Fire Risk Assessment

Property assessed:	1-156 Park Heights 25 Robsart Street London SW9 0BP
Client:	Network Homes Ltd
UPRN:	ROBA0025
Property Classification:	Level 1
Document Print Date:	18/09/2020

FRA Inspection Date:	14/08/2020
FRA Issued to Client:	18/09/2020
FRA valid to:	18/09/2021
FRA completed by:	Savills (UK) Ltd, 33 Margaret Street, London W1G 0JD T: 020 7409 8737 E: fireriskhousing@savills.com

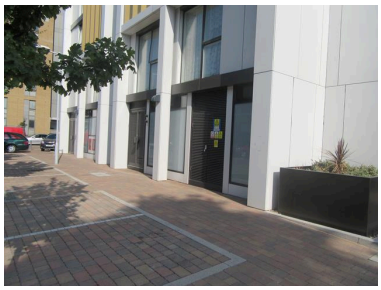
Question	Q.13	Comment: The building has Reynobond ACM rain screen cladding from the second floor upwards, over 130mm Kingspan Kooltherm K15 insulation, according to the specification documents supplied. The lower two storeys have a stone cladding material. The ACM cladding has been tested by BRE and is confirmed as PE. The Kingspan insulation used is not A2 (limited combustibility) and would appear to not have a BS8414 test for the exact system used at Park Heights. Kingspan cite a number of desktop study reports in their literature of systems which utilise their insulation with ACM but the cladding is either FR or A2. The rain screen cladding system will therefore require revision or total replacement but a degree of uncertainty exists around what it should be replaced with until government bring forward any changes to the Building Regulations which will result out of Grenfell. Compliance with current Building Regulations could be achieved by using materials for cladding and insulation which are both A2 and Class 0. Systems which rely on the BR135/BS8414 methodology to justify fire performance are currently in some doubt and it would be risky to adopt any until further clarification on the way forward is forthcoming from the regulators. During the Type 4 inspection the sample location was opened and the insulation depth and type checked to be 130mm Kingspan material. A further panel was opened up which coincided with the line of a compartment floor between flats. It was confirmed that the insulation was interrupted along this line by a stone wool cavity barrier, although it appeared that this would not have been fully in contact with the rear of the ACM cladding leaving a gap of around 20mm in places.

Section	Limiting Fire Spread		
Action ID	130507		
Quantity - Known - Potential	 1 N/A	Recommendation: It is recommended that the rain screen cladding system is revised or replaced to meet the requirements of Building Regulations, including any changes to standards which arise as a result of the Grenfell tower fire. Network Homes have stated that they are in the process of arranging for the ACM cladding to the exterior façade be replaced with a suitable alternative.	
Priority	B	Due Date: 18/09/2021 | Client Status: Assigned Review Status: Unresolved
